UNITED STATES PATENT AND TRADEMARK OFFICE

Office Action Summary	Application No. 10/627,623	Applicant(s) UNGER ET AL.	
	Examiner ERNESTO GARCIA	Art Unit 3679

DETAILED ACTION

FIG. 6.

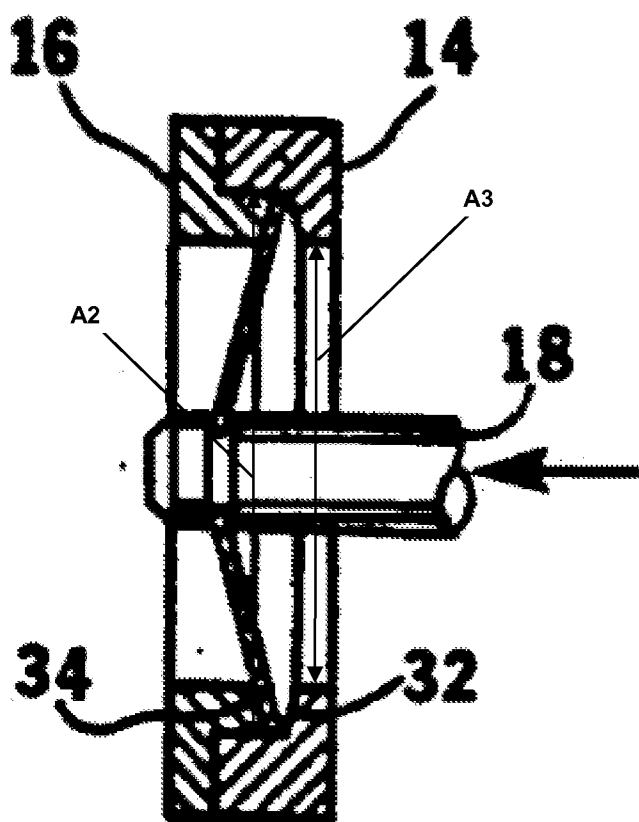
Regarding claim 10, Schwab discloses, in Figure 6, a securing device comprising a spring **12**, a rod **18**, a generally annular spring support **14**, and a generally annular coupling ring **16**. The spring support **14** includes a spring mount **32** projecting in an inner side of the spring support **14**, unitarily being formed with the spring support **14**, and configured to support the spring **12**. The spring support **14** consists of two different inner diameters, in this order, a second inner diameter **A2** (see marked-up attachment), and a third inner diameter **A3** that is smaller than the second inner diameter **A2**. The spring mount **32** is positioned at a region of the spring support **14** located between the second inner diameter **A2** and the third inner diameter **A3**. However, Schwab fails to disclose the support member further consisting of a first inner diameter and threaded holes penetratingly formed through the coupling ring **16**.

Spencer et al. teach, in Figure 1, a support member (unreferenced; however mating with feature 7) having a thread which provides for a first inner diameter similar to applicants' first inner diameter. Since one skilled in the art would have replaced the coupling ring of Schwab with that of Spencer et al. so that instead of press-fitting the coupling ring one would thread the coupling ring in place. Accordingly, one skilled in the art at the time the invention was made would have placed a thread on the spring support **14** of Schwab to enclose the spring **12** and the mere substitution would have inherently provided the first inner diameter thus providing for three different inner diameters in that order. Therefore, as taught by Spencer et al., it would have been

obvious to one of ordinary skill in the art at the time the invention was made to include thread in the spring support thus inherently providing for a first inner diameter so that the coupling ring is threaded in the spring support rather than being press-fitted.
